Proposal for 05 series of amendments to UN Regulation No. 12 - protection of the driver against the steering mechanism in the event of impact

Submitted by the expert from the Netherlands *

The text reproduced below was prepared by the expert from the Netherlands, aiming to update the requirements concerning post-crash electrical safety in the event of frontal impact collision. The modifications to the current text of the UN Regulation are marked in bold for new or strikethrough for deleted characters.

Figure 4
Example of test method using DC power supply

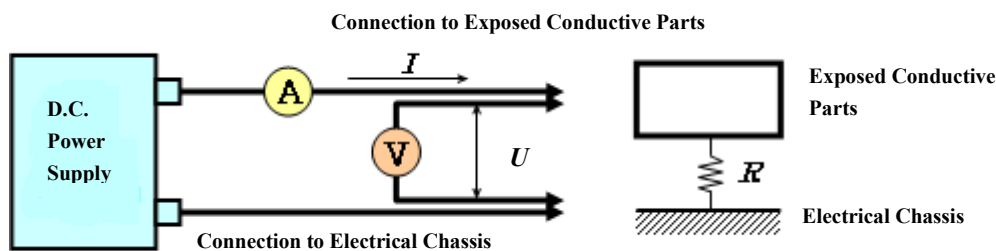
- (ii) Resolution: 0.01 Ω or less;
 - (iii) The resistance R shall be less than 0.1 Ω .
- (b) Test method using DC power supply, voltmeter and ammeter.
- The DC power supply, voltmeter and ammeter are connected to the measuring points (Typically, electrical chassis and electro conductive enclosure/electrical protection barrier).
- The voltage of the DC power supply is adjusted so that the current flow becomes at least 0.2 A.
- The current "I" and the voltage "U" are measured.
- The resistance "R" is calculated according to the following formula:

Note: If lead wires are used for voltage and current measurement, each lead wire shall be independently connected to the electrical protection barrier/enclosure/electrical chassis. Terminal can be common for voltage measurement and current measurement.

Example of the test method using DC power supply, voltmeter and ammeter is shown below.

Figure 5
Measurement of U_1'

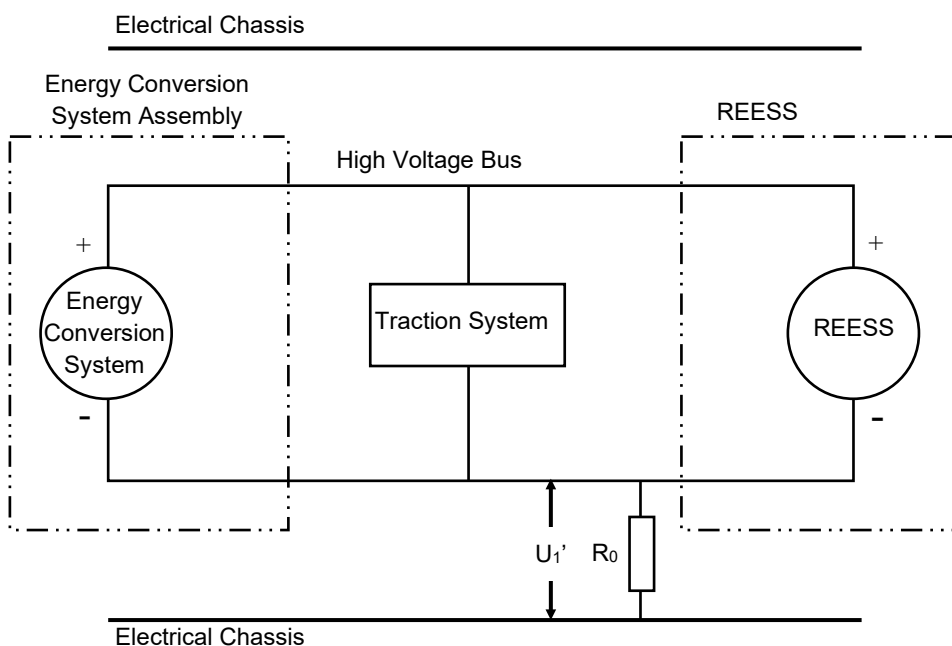
If U_1 is greater than or equal to U_2 , a standard known resistance (R_0) is inserted between the negative side of the high voltage bus and the electrical chassis. With R_0 installed, the voltage (U_1') between the negative side of the high voltage bus and the electrical chassis is measured (see Figure 5).

$$R_i = R_0 * U_b * (1/U_1' - 1/U_1)$$

Figure 6
Measurement of U_2'

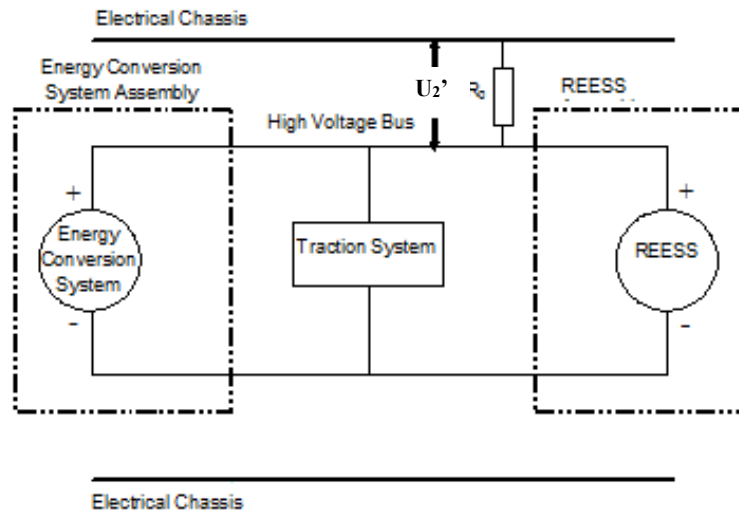
If U_2 is greater than U_1 , insert a standard known resistance (R_0) between the positive side of the high voltage bus and the electrical chassis. With R_0 installed, measure the voltage (U_2') between the positive side of the high voltage bus and the electrical chassis (see Figure 6 below). The electrical isolation (R_i) is calculated according to the following formula:

$$R_i = R_0 * U_b * (1/U_2' - 1/U_2)$$
